Site Plan Review

Reviewed for compliance with City Ordinance, Building and Fire Codes
Conditions and mark-ups noted throughout plan set must be addressed prior to final approval

City of Rochester Hills, Oakland County, Michigan SITE PLAN DOCUMENTS

Marketplace of Rochester Hills 3900 Industrial Dr.

SHEET
Engineering Site Plan

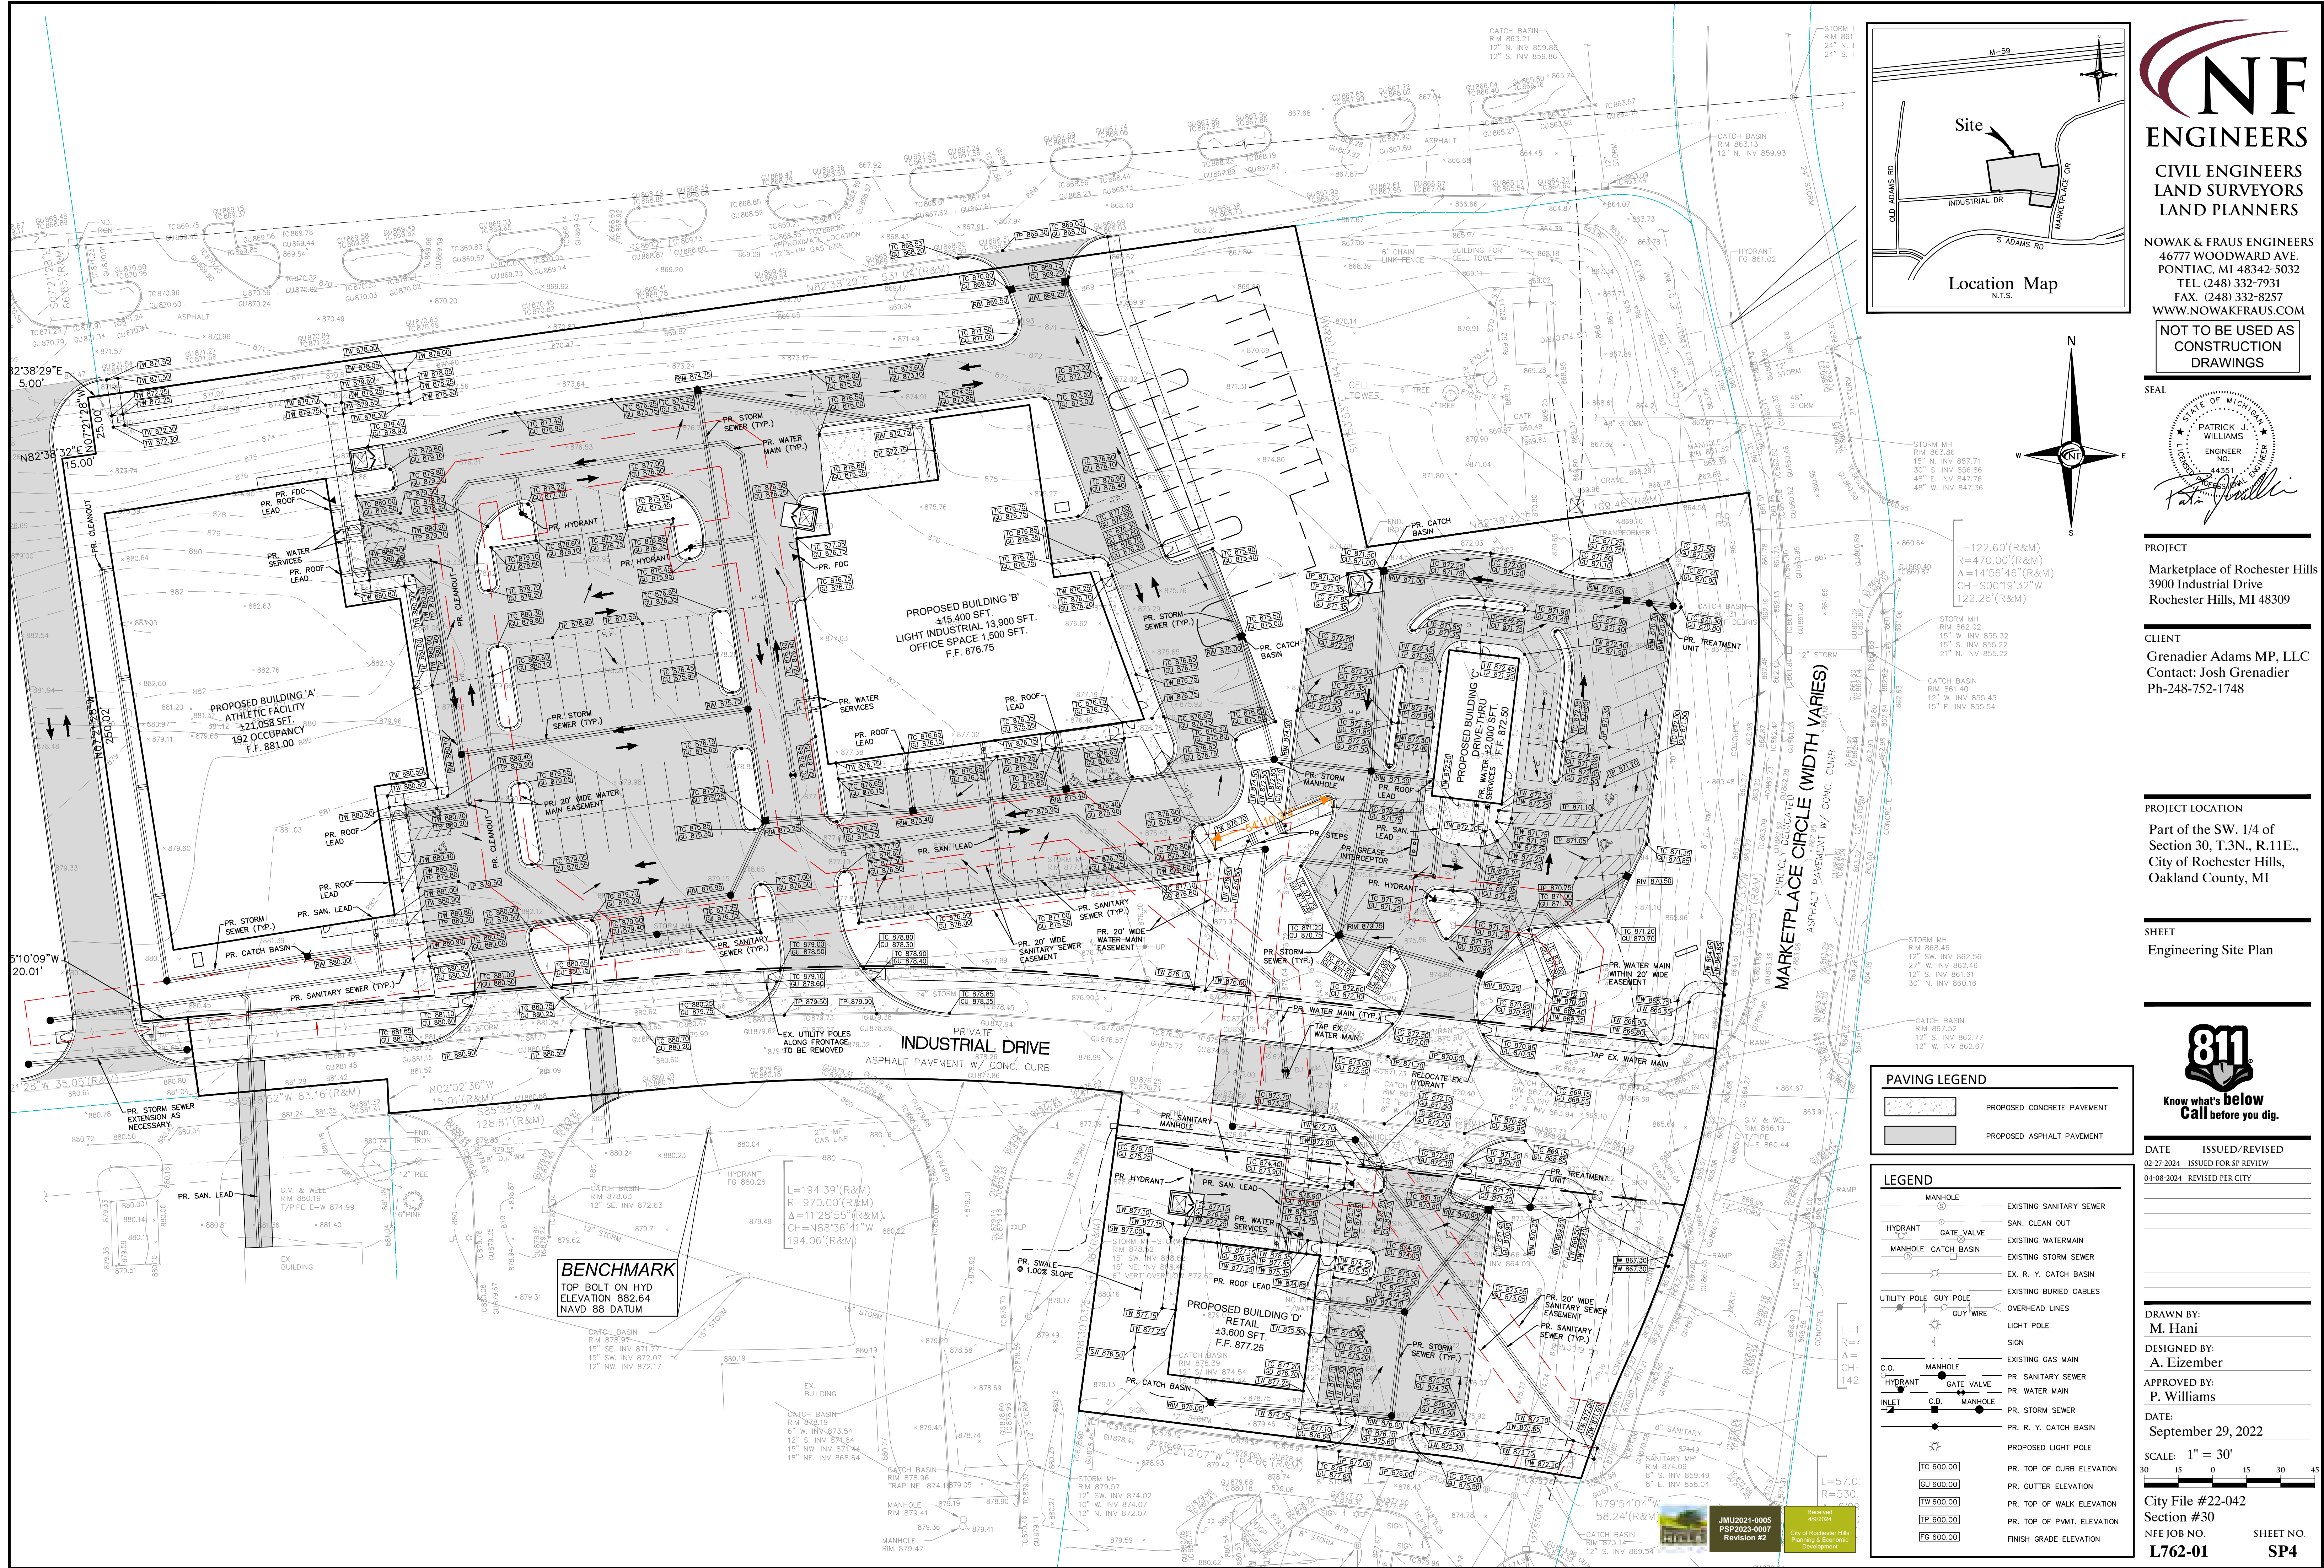
There are several instances where the auto turn hangs over the curb. The fire apparatus needs to maneuver through the site with zero overhang over the curbs measured at the front of curb. These areas are highlighted in orange.

Provide vehicle impact protection for the fire department connection. See installation requirements here:

The aerial apparatus access road shall have a minimum unobstructed width of 26 feet exclusive of shoulders. This measurement is taken at front of curb.

provide this documentation

shift hydrant here closer to curb

Many of these are within the gutter pan, no actually hitting the curb. We have cleaned up the turning movements to address the concerns.

Note added that FDC shall include bollard protection per city requirements.

Curb to curb dimension is 26'. Label added.

Owner/Developer to coordinate flow test.

Hydrant has been shifted closer to back of curb.
